**TOWN OF TIMNATH, COLORADO
RESOLUTION NO. 14, SERIES 2023**

**A RESOLUTION OF THE TOWN COUNCIL OF THE TOWN OF TIMNATH TO
DENY THE FLOCKHART HARMONY SUBDIVISION, GENERALLY LOCATED
NORTH OF ADJACENT TO HARMONY ROAD, AND WEST OF AND ADJACENT TO
MAIN STREET**

FLOCKHART HARMONY SUBDIVISION FILING NO. 1

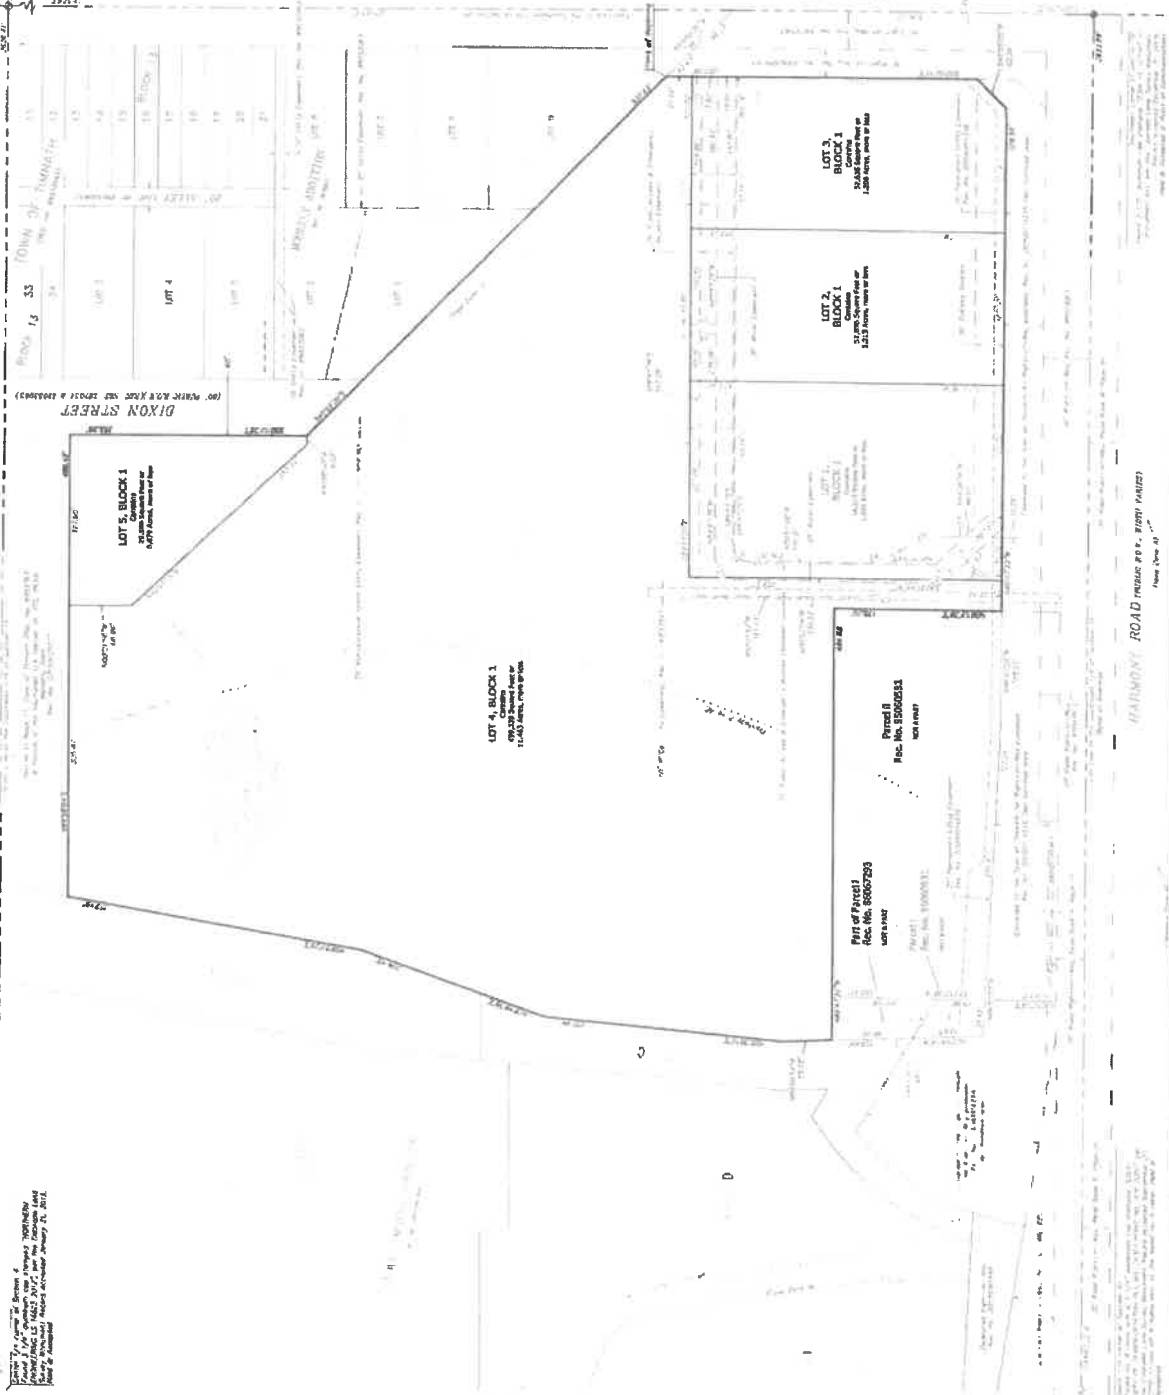
The transportation design is not adequate for the existing and planned capacities of adjacent streets. This submittal does not meet the Town's technical standards for transportation access identified in the Town's Design Standards and LCUASS. Staff has repeatedly and consistently informed the applicant that the design does not meet the Town's criteria as follows:

The submittals continue to focus on just three commercial lots which are part of a much larger development parcel. There is no Master Plan for this property, so staff has continued to request clarification on the ultimate commercial uses for the purpose of evaluating the ultimate traffic volume and access for this property as required by the LCUASS. Initially the Traffic Impact Study was revised to add substantial traffic increase for full property buildout, but due to the problems arising from the resulting increase in volume of traffic, the study was reduced back down to only the initial three lots while adding, upon staff's request, a note on Figure 1 of the report that Lot 4 (remainder of the property) will have "No Future Development". However, Lot 4's future intended use is specified on the Final Plat as "No Immediate Development Plans". The code requires the landowner to either commit to no future development of Lot 4 or include the anticipated future traffic volumes from Lot 4 in the current Traffic Impact Study so the access points to the property can be designed with the future traffic volumes in mind. It has done neither.

1. The project access from Main Street and future Timnath Parkway is depicted as a Right In / Right Out. Town criteria for access to a Major Arterial is 660' between intersections. The distance proposed for this development is approximately 300'. Staff has agreed to consider a waiver, assuming the applicant requests a waiver pursuant to LUC 2.9.15 and can provide a written engineering analysis that accessing the future 4-lane Timnath Parkway with a Right In / Right Out, a mere 300' from the Harmony Road intersection, will be a safe movement. To date neither a waiver application nor any written analysis has been provided.

2. The access from Harmony Road
 - a. Per the 2014 court stipulated settlement agreement between the property owner and the Town, the owner and the Town agreed that "the access to plaintiff's property remains as it is now in place and the Town will permit a right turn lane into and right turn out of the property". Applicant continues to submit plans for, and insist upon, a 3/4 turn movement from

Harmony Road. Staff does not support a 3/4 turn movement at this location.

b. Staff continues to request justification from the applicant regarding its position that the noncompliant design for the left turn lane will be safe and functional. The reply from the applicant is to "refer to the Traffic Impact Study for design safety and criteria to provided comment". However, no such discussion is provided in the Study.

c. If the 3/4 turn movement is allowed (which is not supported by staff), it is non-complaint with LCUASS for the following reasons:

i. Does not meet spacing requirements from Main Street for a driveway/intersection.

ii. Is not designed to prevent south bound vehicles from turning left.

iii. Does not meet storage requirements if entire property is developed (#1 comment above).

iv. Does not have a transition taper into the turn lane, or deceleration area outside of thru traffic.

v. Is not fully shadowed (arterial left turn lane design requires thru traffic to be fully shifted before moving into the left turn lane.

vi. Does not have the required transition taper of 720' to shift thru traffic around the turn lane. Applicant provided 180', which would be appropriate for a 25 MPH road.

d. Applicant has indicated the access would need to be signalized in the future. Staff has made it clear to the applicant that the location of the access on Harmony Road does not meet the spacing requirements for a traffic signal in that it would only be 600' west of the Main Street traffic signal. However, the Transportation Impact Study provided by the applicant continues to assume a traffic signal at this location to achieve an acceptable level of service.
